**Re: Initial Submission Review – Prairie Point Site Plan No 1 (Kings Point North) – Site Plan and Plat**  
Application Number: **DA-1609-22**  
Case Numbers: **2022-4045-00, 2022-3066-00**

## Initial Submission Review

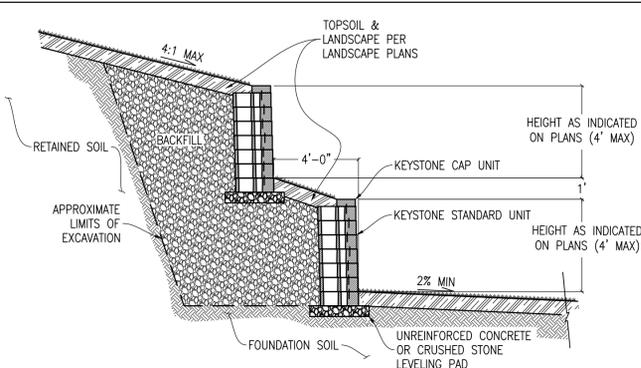
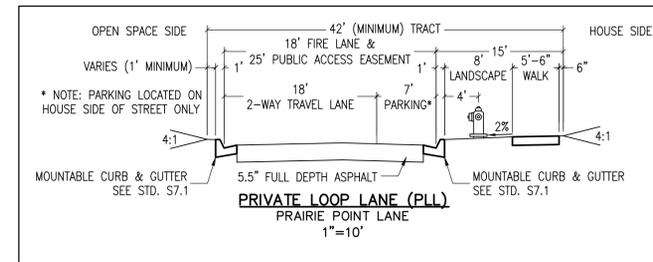
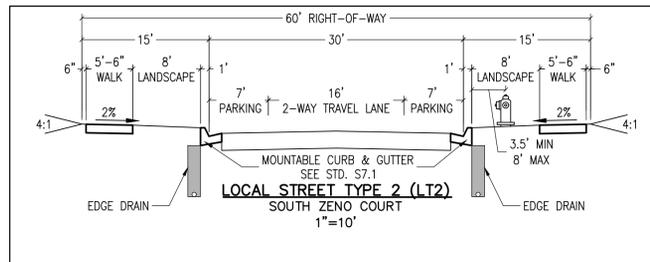
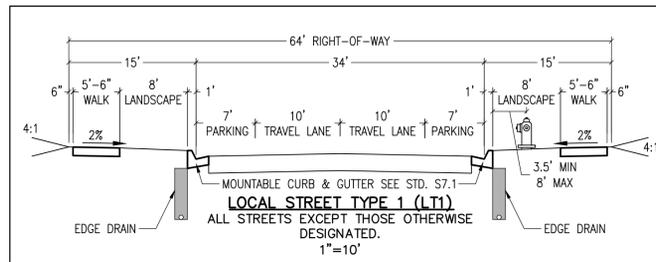
See red lines.

**PRAIRIE POINT FILING 1**  
**STREET & RETAINING WALL CROSS SECTIONS; SIDEWALK PLAN**

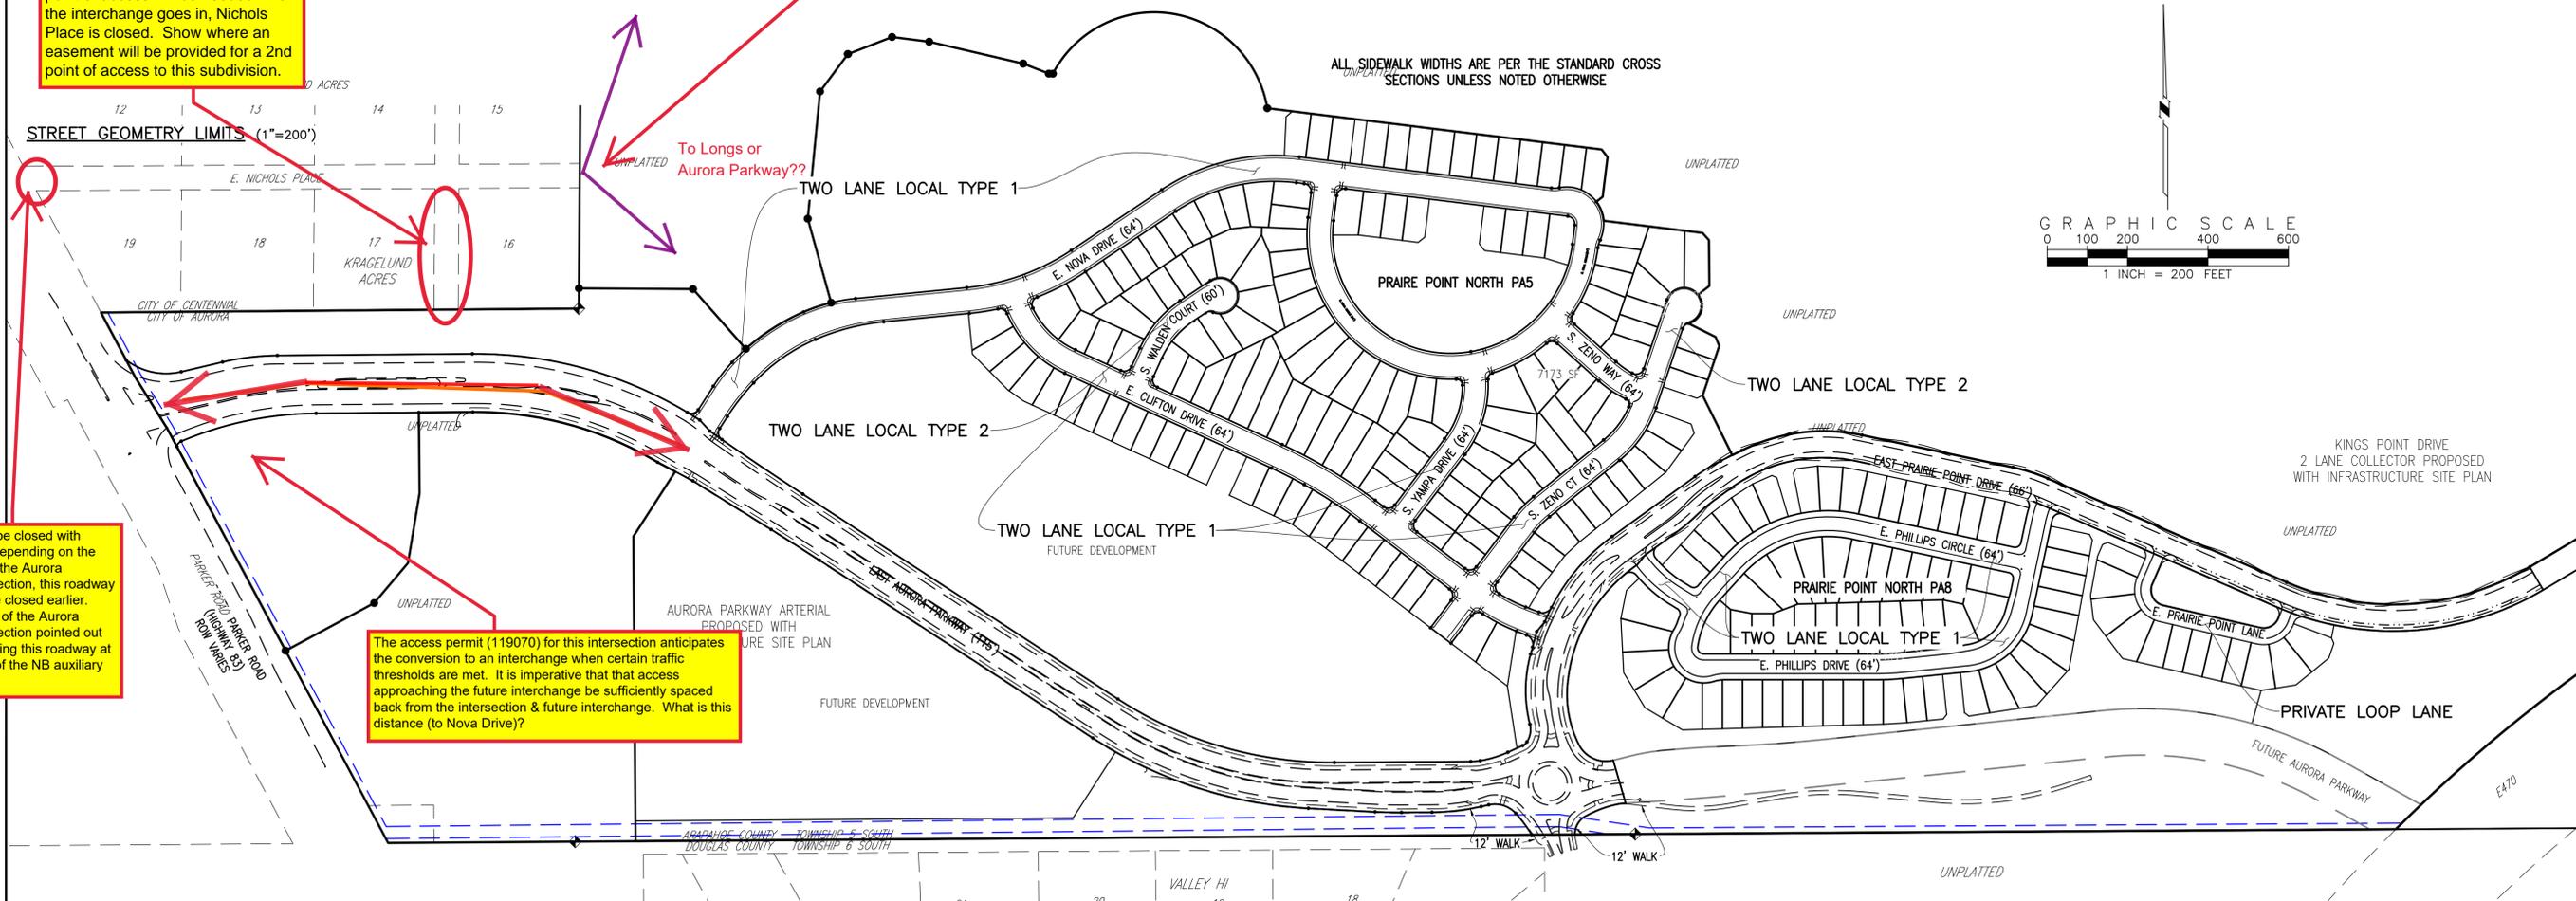
Please show-illustrate the planned secondary access (easement) to the Kraaglund Acres subdivision

This is inaccurate. The City of Centennial vacated this road. A 2nd point of access will be needed when the interchange goes in, Nichols Place is closed. Show where an easement will be provided for a 2nd point of access to this subdivision.

Right in-out to be closed with interchange. Depending on the final design for the Aurora Parkway intersection, this roadway may need to be closed earlier. Our last review of the Aurora Parkway intersection pointed out issues with having this roadway at the gore point of the NB auxiliary lane.

The access permit (119070) for this intersection anticipates the conversion to an interchange when certain traffic thresholds are met. It is imperative that that access approaching the future interchange be sufficiently spaced back from the intersection & future interchange. What is this distance (to Nova Drive)?
